Tennessee Valley Authority, 1101 Market Street, Chattanooga, TN 37402

CNL-17-118

Subject: Supplemental Information Related to Environmental Report Figures in Support of  
Early Site Permit Application for Clinch River Nuclear Site

### Supplemental Information Associated with Environmental Report Figures

Figure 2.4.1-1. Land Cover Types on the CRN Site

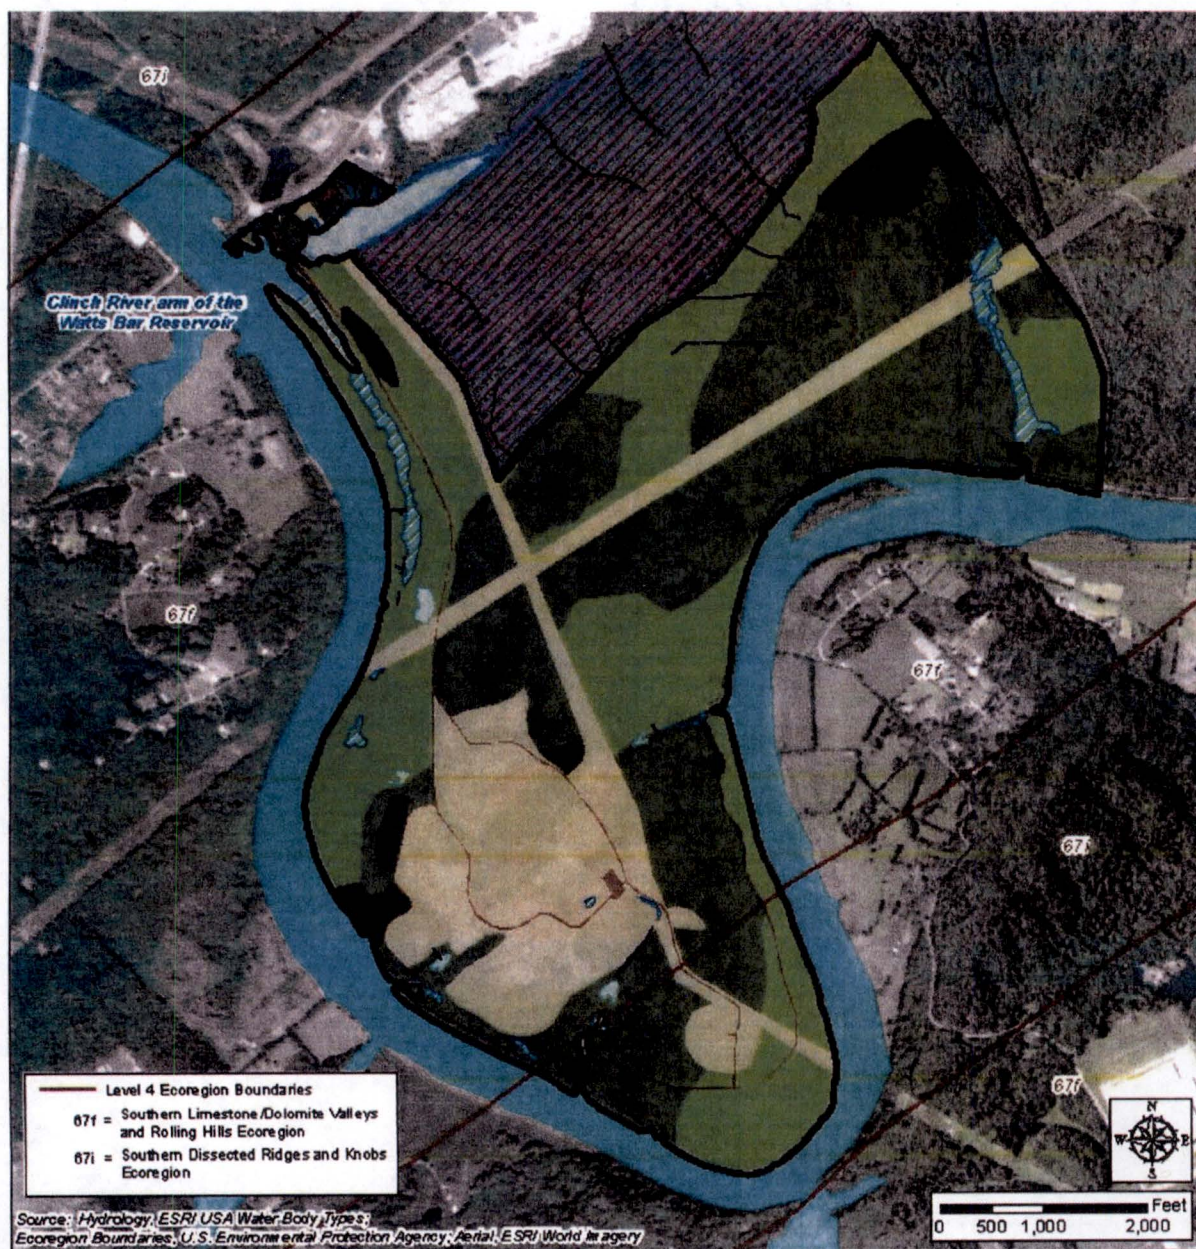
During the public meeting held on August 14, 2017, the NRC staff requested clarification of the source data used in the development of ER Figures 2.4.1-1 and 4.3-1.

The source data used to inform ER Figures 2.4.1-1 and 4.3-1 were CRN Site and Barge/Traffic Area (BTA) field surveys conducted by TVA biologists to characterize vegetation communities, wetlands, and ponds. The findings from these surveys are described in ER Subsection 2.4.1.1, "Upland Habitats," and ER Subsection 2.4.1.2, "Wetland Habitats." Based on the interpretation of aerial imagery, in conjunction with the descriptions of vegetation communities, wetlands, and water bodies provided by these field surveys, dominant vegetation communities and other land cover types were delineated on aerial photographs by hand. This information was converted to Geographic Information Systems (GIS) layers and mapped using GIS to create ER Figures 2.4.1-1 and 4.3-1. Acreages for the land cover types were then calculated using the GIS polygons (shown in the figures). Acreages for the land cover types are summarized in ER Table 2.4.1-1. As noted in ER Table 2.4.1-1, wetland acreages were accounted for in the vegetation community type in which they occur (i.e., deciduous forest, mixed forest, or herbaceous).

ER Figure 2.4.1-1 is being revised as indicated.

ER Figures 2.4.1-1 and 4.3-1 are being revised to include the source data references. In addition, ER Table 2.4.1-1, Note 1 is being revised to reflect the method used to develop the land cover types.
